# UNITED STATES PATENT AND TRADEMARK OFFICE

10/582,046

<b>Office Action Summary</b>	<b>Application No.</b> 10/582,046	<b>Applicant(s)</b> STROBEL, GUSTAV	
	<b>Examiner</b> Joshua Rodden	<b>Art Unit</b> 3637

### **DETAILED ACTION**

Annotated Figure 3 (Weldner)

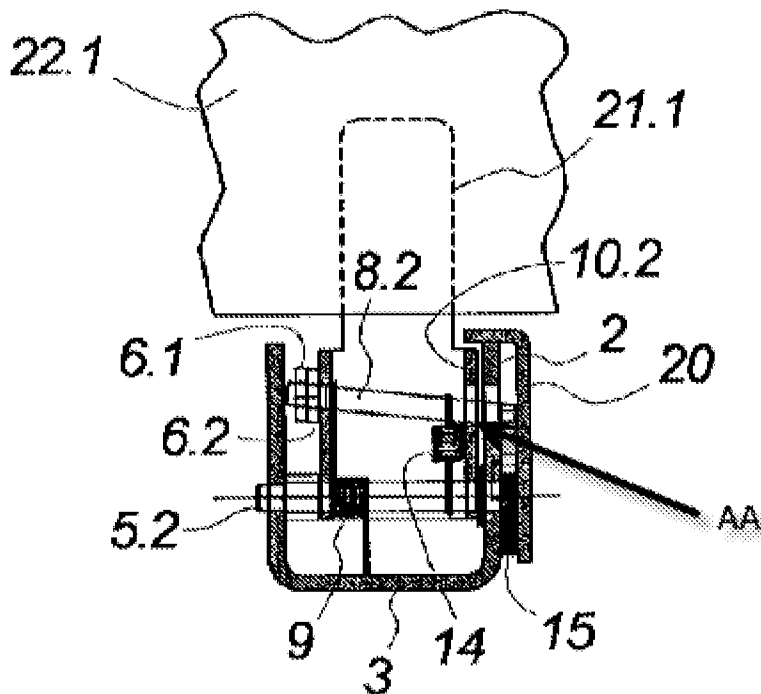
Regarding **Claims 12**, **Weldner** teaches: **Claim 12** – a stacking column comprising two side walls (2) and a plurality of latches (21.1-21.3) arranged between the side walls (2), wherein each latch (21.1-21.3) is integral with a pin (5.1-5.3) which allows for rotation between a rest position into a working position, (Figures 1-4); wherein a cutout portion (area between side walls (10.3) and holes (AA)) exposes a circumferential surface of the pin (5.3), and a pin holder (hole in bottoms of bottom of side wall (10.3)) which surrounds the circumferential surface of the pin (5.3), (Figure 1 and Annotated Figure 3 Below); **Claim 14** – wherein at least two adjacent pins (5.1-5.3) maintain a distance from each other which is greater than the material thickness of the latch in the region of the pin holder (hole in bottoms of bottom of side wall (10.3)), (Figures 1-3); **Claim 15** – wherein the latches (21.1-21.3) are of a single-piece design, (Figures 1-3).

**Weldner** does not teach the pin holder having an arcuate inner surface which only partially surrounds not more than half of the circumferential surface of the pin in an arcuately curved manner (**Claim 12**); and wherein at least two pins maintain a distance from each other which is greater than and substantially the same as a material thickness of the latch in the region of the pin holder (**Claim 14**). However, **Strobel** teaches: **Claim 12** - a stacking column comprising two side walls (2 and 3), a plurality of latches (4) arranged between the side walls (2 and 3), wherein each latch (4) is integral with a pin (11.1 and 11.2) which allows for rotation of the latches (4) between a rest position and a working position (See the "BACKGROUND OF THE INVENTION" section of the specification), (Figures 1-3); wherein the bottom portion of the latch has hole (10) for engaging the pin (11.1 and 11.2) and additionally has an arcuate surface (BB) which

Regarding **Claims 13, 20 and 21, Weldner as modified by Strobel** teaches the stacking column as described above, in addition to **Weldner** teaching: **Claim 13** - wherein the latches (21.1-21.3) are assigned a locking device (6.1-6.3, 8.1-8.3, 12.1-12.4 and 13.1-13.4) which fixes at least some of the latches (21.1-21.3) in the working position, (Figures 1-4); **Claim 20** – wherein a stop lug (10.2) projects from the upper part of the cutout (AA) to stop part of the locking device (8.2) from leaving the cutout (AA), (Annotated Figure 3 Above); **Claim 21** – wherein the locking device (8.2) moves (up and down) in the cutout (upper and lower portions of hole (AA)) by means of a small rail (8.2), (Figure 4 and Annotated Figure 3 Above).

Annotated Figure 4 (Strobel)

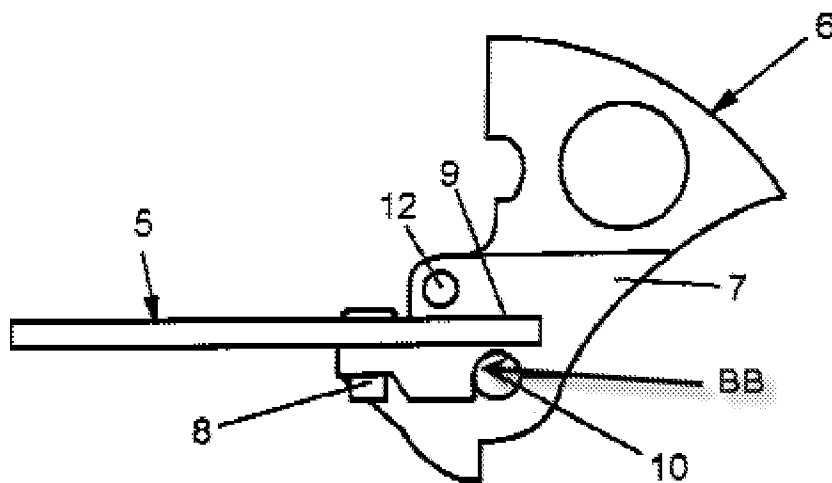
only partially surrounds not more than half of the circumferential surface of the pin (11.1 and 11.2), (Figures 1-4 and Annotated Figure 4 Below); **Claim 14** – wherein at least two pins (11.1 and 11.2) maintain a distance from each other which is greater than and substantially the same as a material thickness of the latch (4) in the region of the pin holder (10 and BB), (Figure 1 and Annotated Figure 4 below). Therefore, it would have been obvious to one of ordinary skill in the art to modify the bottom portion of the latches of **Weldner** to have the pin holder having an additional arcuate inner surface which only partially surrounds not more than half of the circumferential surface of the pin in an arcuately curved manner (**Claim 12**) and wherein at least two pins maintain a distance from each other which is greater than and substantially the same as a material thickness of the latch in the region of the pin holder (**Claim 14**) as taught by **Strobel** for the purposes of having latches which more efficiently contact and rotate about their corresponding pins and for having latches which can be located closer to one another for holding smaller objects.
